COMMITTEE OF THE WHOLE MAY 20, 2003

KEELE VALLEY CLOSURE PLAN GENERAL PLANNING FILE 22.9.3.9 CITY OF TORONTO

To update Council on the draft Closure Plan for the Keele Valley Landfill site, and provide Vaughan with an opportunity to provide comments to the City of Toronto and MOE on the draft closure plan.

Proposed Final Contour Plan

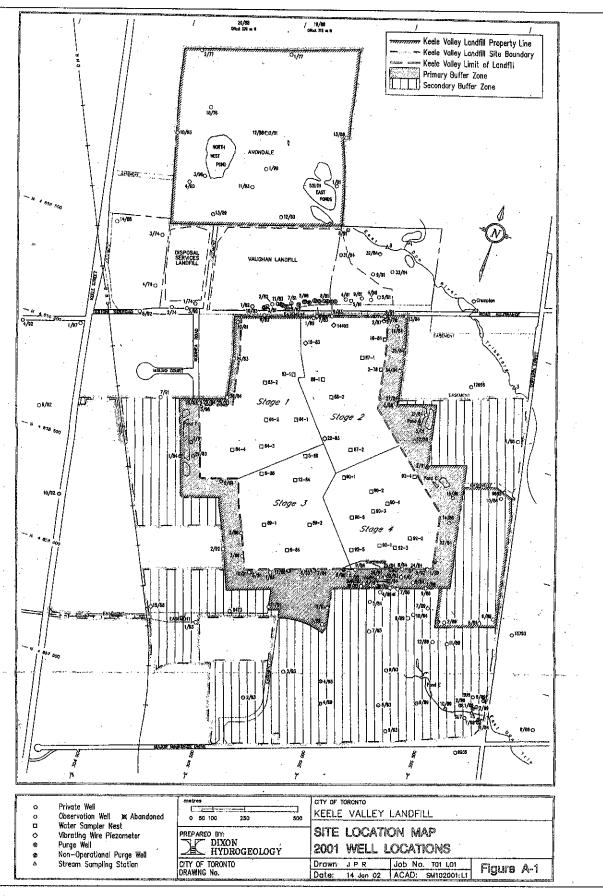
The constraints on the site during the next five years are acknowledged. However the draft Closure Plan does not provide any direction towards "an end use plan, designed to achieve the maximum public benefit". The random planting of seedlings is of limited value with no particular relationship toward an end use plan. The reference to "future passive recreational developments in subsequent phases" is so ill defined and open ended as to be of little value.

The Draft Closure Plan falls considerably short of both the requirements of the Certificate of Approval and the City's expectations based on discussions with Toronto with respect to establishing a major vegetation planting program on KVL. An end use plan, designed to achieve the maximum public benefit needs to be prepared to form part of the Closure Plan. It should identify passive recreational developments such as pathways and trailheads and a related landscape master plan comprised of trees, shrubs and grasses. This plan should be assessed against the operational requirements of both the short and longer term and a phasing plan established for its implementation. As certain areas of the Disposal Area have had final cover for almost 15 years there may be opportunities to implement portions of the landscape master plan now, in advance of public access, recognizing that other areas may be phased in at the end of the five year restricted use period.

The top soil and hydro seeding proposed is a minimal standard and not acceptable given the objective of establishing an "end use plan, designed to achieve the maximum public benefit". A comprehensive assessment of final cover is required which determines the necessary topsoil depth to support trees and plants, identifies tree species best suited to the environment of the site and defines the planting and maintenance requirements to ensure their survival. This assessment should form part of a master landscape plan prepared in consultation with the City of Vaughan.

- 1. The preparation of an end use plan, designed to achieve the maximum public benefit which would include:
 - a) passive recreational opportunities and facilities such as trails and trail heads;
 - b) related landscaping including grasses, wild flowers, shrubs and trees;
 - c) site access locations and fencing;

- d) the sufficiency of soil cover material to adequately support vegetation such as trees and shrubs in addition to the minimal hydro seeding proposed:
- e) phasing and implementation of the plan in a coordinated fashion with the other operational requirements of the site.
- 2. The role of the Keele Valley Liaison Committee to address community concerns and monitoring progress of the closure plan;
- 3. The adequacy of the Closure Program as it pertains to the Teston Road purge well system.
- 4. That all buildings to remain on site operated by Toronto shall be used only for the purposes of maintenance and monitoring of the closed landfill;

Primary & Secondary Buffer Areas & Well Locations

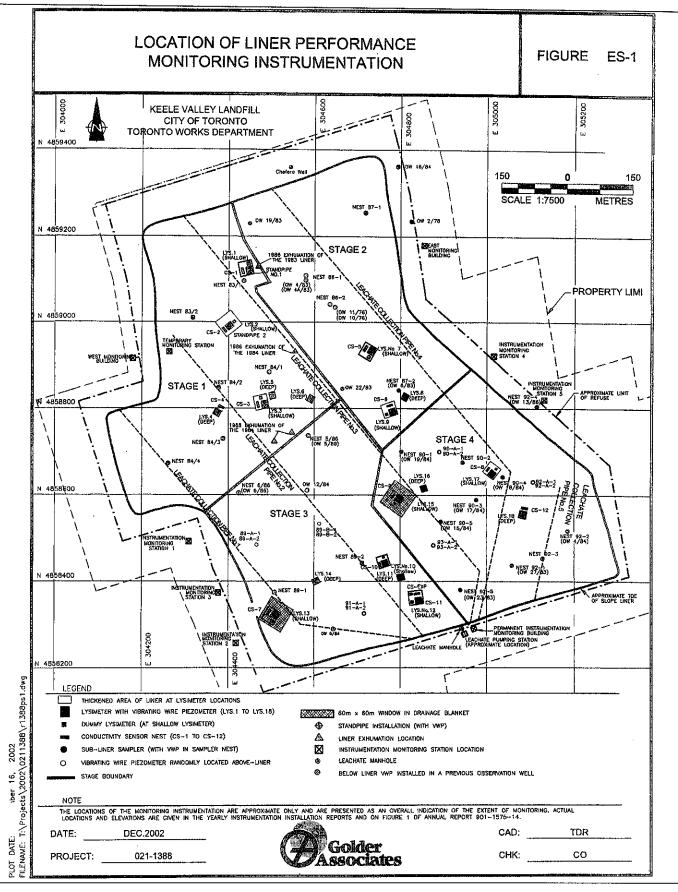
Vaughan has been aware since the initial approval of KVL that the primary buffer will function as an infrastructure and maintenance corridor around the disposal area. The continuation of this role into the future is understood. It may be necessary, as part of the passive recreational use of the disposal area, to have defined locations where the buffer must be crossed by the public. The suitable locations for such crossings should be defined in the Closure Plan as part of the "end use plan" including suitable locations for landscape material. Should the Region of York be permitted to establish its public drop off facility the landscape and facility plan for this operation should be integrated into the Closure Plan.

This section of the draft Closure Report provides an outline of the management, monitoring, maintenance and inspection of the leachate collection system. There is no specific reference to the Teston Rd. purge well system that intercepts leachate from the former township landfill and it is not included on the plan identifying the Leachate Collection System Layout.

The Certificate of Approval provides that Toronto shall install and operate the Teston Road purge well system to the satisfaction of the Ministry of Environment. Accordingly, the Ministry of Environment should be satisfied that the system is appropriately addressed in the Closure Plan. The City of Vaughan should be circulated copies of the monitoring reports on a regular basis.
